**SR-13A MINE PERMIT AMENDMENT  
APPLICATION PERMIT No. M-1977-311  
Response to Adequacy Review #2**

*February 1, 2013*

**SR-13A Mine, File No. M-1977-311, Amendment (AM1) Application**  
**Adequacy Review (2)**

C:\Land Projects\2009\COTTER CORPORATION SR-13A\dwg\SR-13A\_DRAINAGE-plan.dwg, 1/24/2013 6:03:15 PM, Rick

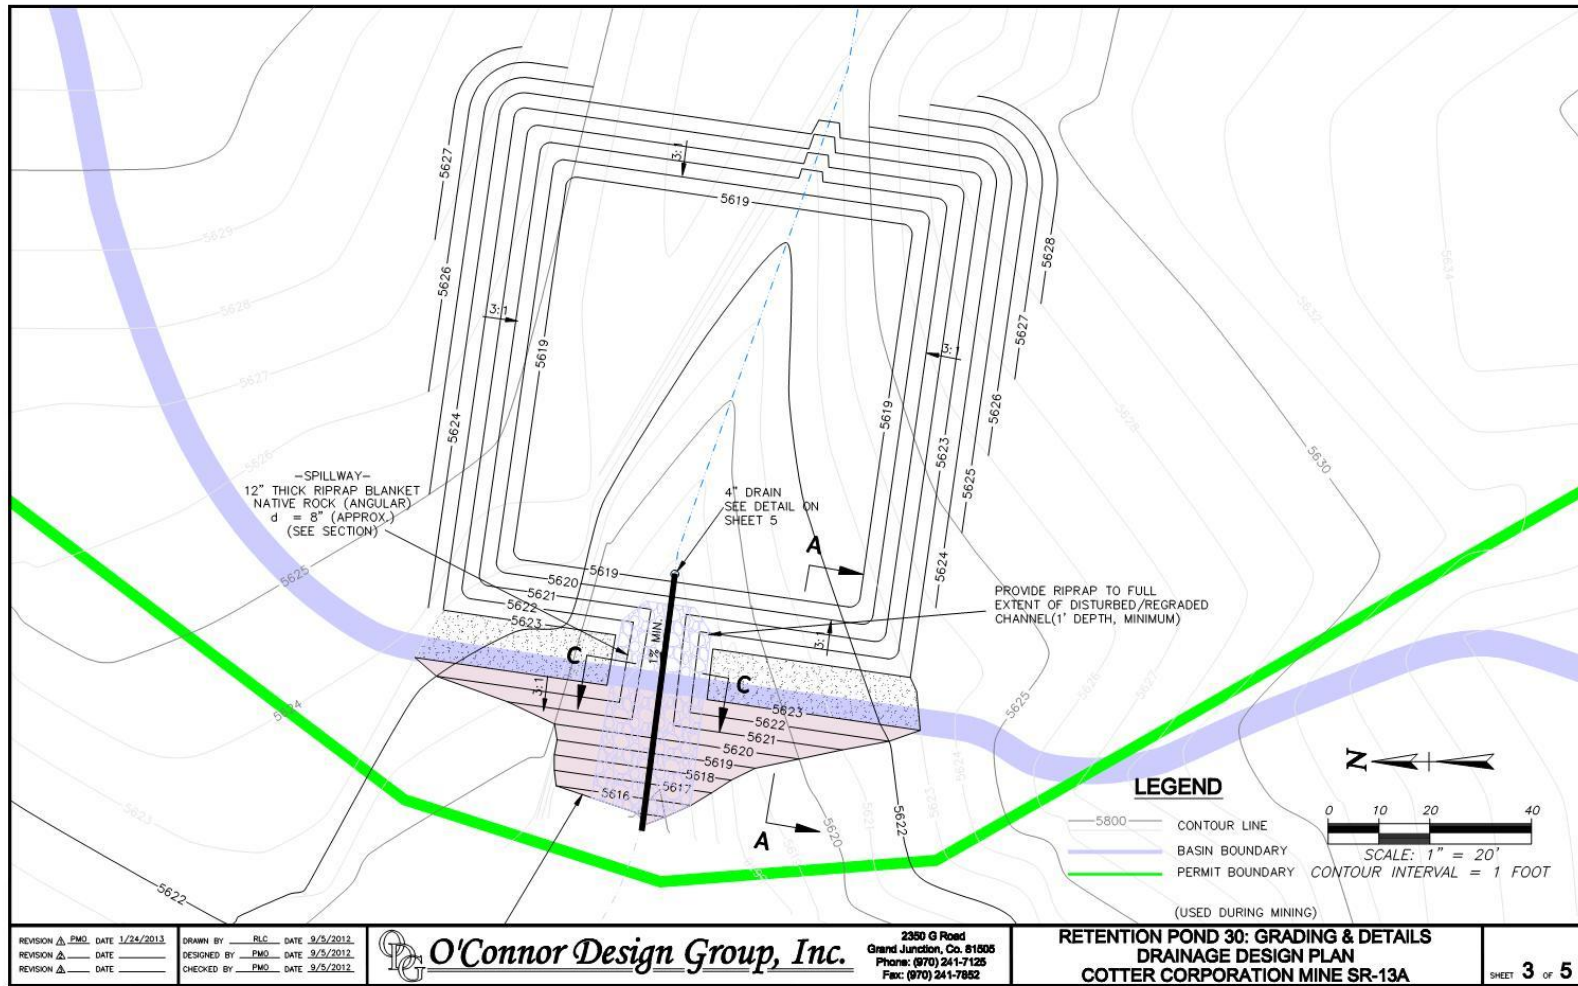
- 11. Sheet 2. Please label engineered design channel reaches on the drawing consistent with the labels used for the FlowMaster analyses to enable the DRMS to evaluate the channel slopes.*

**Sheet 2 of the ESWMP has been revised to reflect channel labels consistent with the cross-section details and flow worksheets. These drawings and analysis worksheets are included in attachments #4 and #6 of this document.**

C:\Land Projects\2006COTTER CORPORATION SR-13A\dwg\SR-13A DRAINAGE pond.dwg, 1/24/2013 8:01:58 PM, RLC

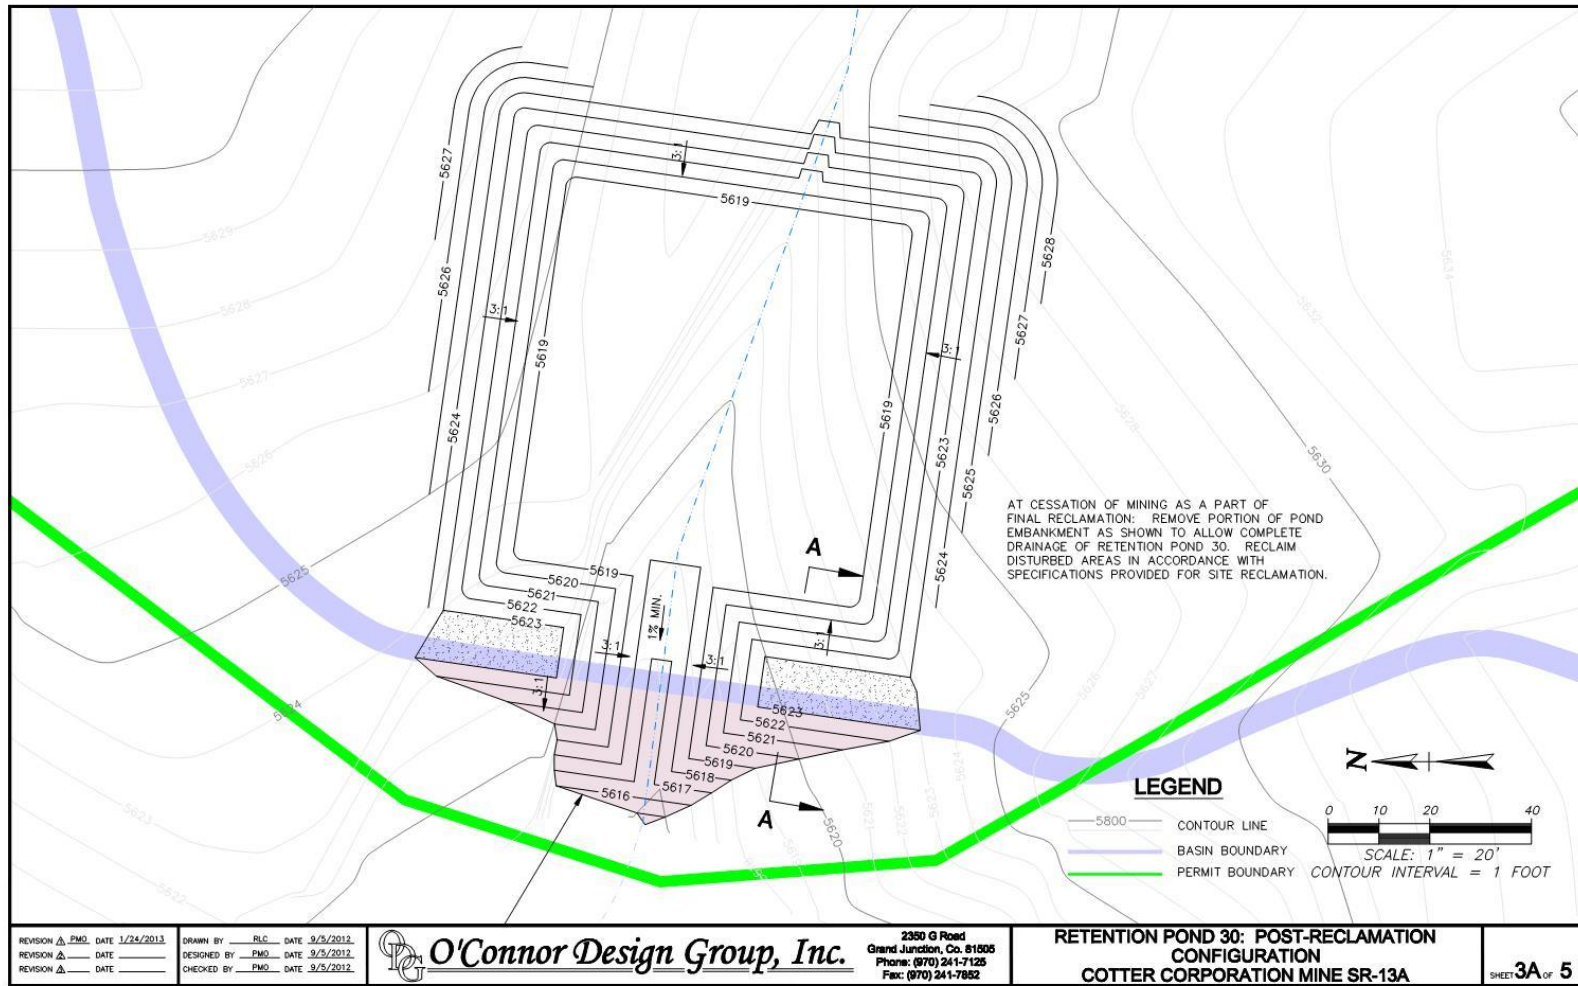
6. *Page ESWMP-6, section 7.4 paragraph and Retention Pond Drainage Design Plan (Sheet 5 of 5). The 100-year, 24-hour runoff volume criteria used for sizing storage in the pond is acceptable. However, a spillway is necessary to pass runoff from successive storms as there is no way presented in the Retention Pond design plan to drain the pond via gravity. As such, the emergency spillway for the ponds needs to be designed to convey 100-year peak flow, assuming the ponds are full (to the spillway invert elevation) at the onset of the design storm. Please provide analyses and designs to demonstrate the spillway has the capacity to pass the peak flow resulting from the 100-year, 24-hour design storm. (NOTE – The DRMS checked with the Colorado Division of Water Resources (DOWR) District 63 water commissioner (Tom Brigham) regarding the status of the Dolores River appropriations. Mr. Brigham state that the Dolores River is not currently over appropriated and as such, DWR has no current requirement to release retained stormwater within 72 hours. He emphasized this condition is seasonal and is subject to change.) The DRMS suggests the Operator consider a low level outlet be designed into the pond in case a call is put on the Dolores River, the Operator can comply with the DOWR requirements.*

- 12. Sheet 3. Please provide spillway location, design (sections and profile), and specifications sufficient to convey the design flow to the toe of the embankment.*

**The retention pond has been redesigned, as requested, to provide “retention” storage of the 10-year event with an armored spillway capable of passing the 100-year event. In addition, based on your comments and those received later from the Division of Water Resources, the pond will have a small drain pipe with screened inlet in the bottom to allow the impoundment to drain fully within the 72 hour timeframe after a storm event. Revised drawings (sheets 3, 3, 3A and 5) are included in attachment #6 of this document.**

**The drawings (sheets 3 and 5 of attachment #6) have been revised to include an armored spillway capable of conveying the 100-year event to the toe of the embankment. The design was determined by comparing hydraulic analysis methods and utilizing the most conservative. The spillway was analyzed as a “broad-crested weir” and as an “open channel”. Results were very similar, but the broad-crested weir showed a slightly greater flow depth in the outlet and this is what the channel dimensions and armoring limits were based on. Results are included in attachment #5 of this document, labeled “Worksheet for Broad Crested Weir - 1” and “Worksheet for Trapezoidal Channel – 1”.**

C:\Land Projects\2006COTTER CORPORATION SR-13A\dwg\SR-13A\_DRAINAGE\_POND-RECLAIMED.dwg, 1/24/2013 8:02:38 PM, RLC

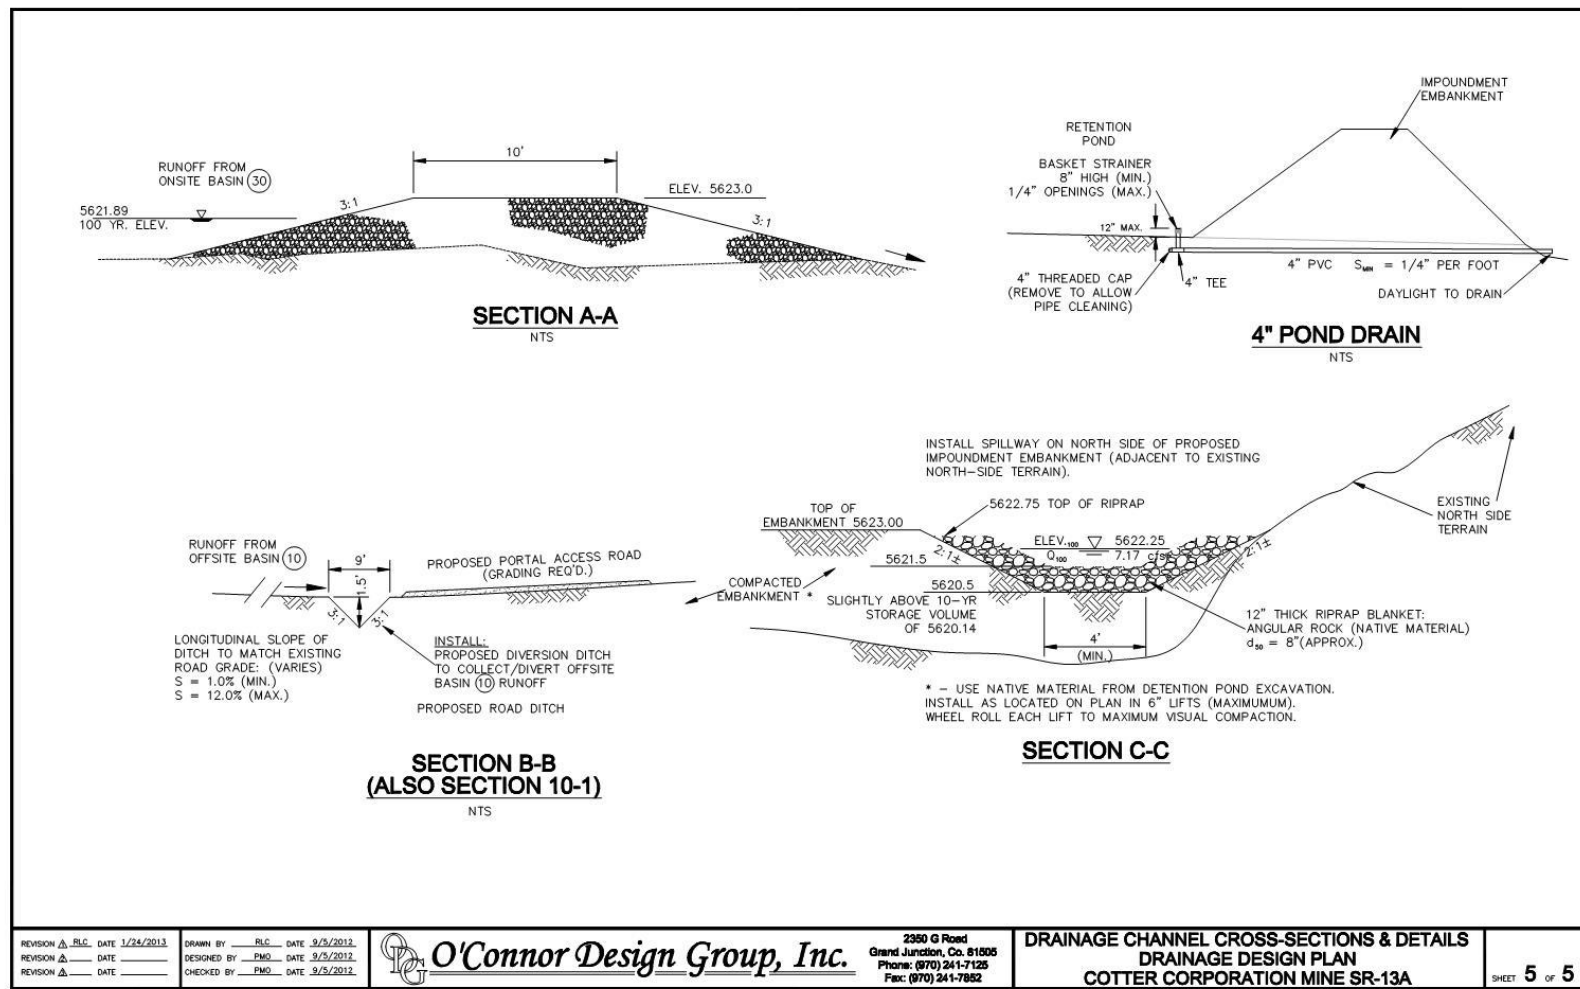
7. *Page ESWMP-7, last paragraph. This paragraph references the Environmental Protection Plan for details related to the reclamation of stormwater features. The DRMS could find no discussion of stormwater feature reclamation in Exhibit T, nor any*

*discussion of the retention pond in the Exhibit D Reclamation Plan. Please indicate whether the retention pond will be left in place, breached, filled in, etc.*

**It is now the intention to have the retention pond embankment partially removed at the final reclamation stage to allow stormwater to pass through the pond with no retention of surface runoff. Revised drawing Sheet 3A is included in attachment #5 to indicate this.**
